Re: Sequoia Apartments
5130 Sequoia Rd. NW
Traffic Circulation Layout
Architect's Stamp 2-25-22 (G11-D058)

DRAINAGE AND TRANSPORTATION INFORMATION SHEET

Re: Traffic layout certification, 5130 Sequoia Rd NW, BP 2022-04675

SITE PLAN

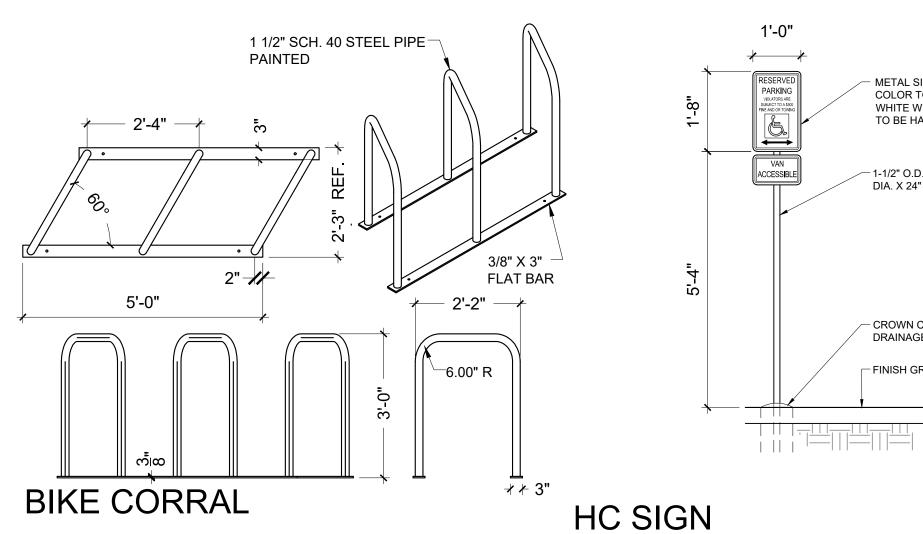
I am writing in response to your letter of April 16, 2022.

- 1. Keyed note "Z" changed to COA standard drawing 2444 Detail D.
- 2. Please reference ADA parking detail in top left corner of the sheet. On the detail a note stating "12" HIGH LETTERING WITHIN ACCESS AISLE".
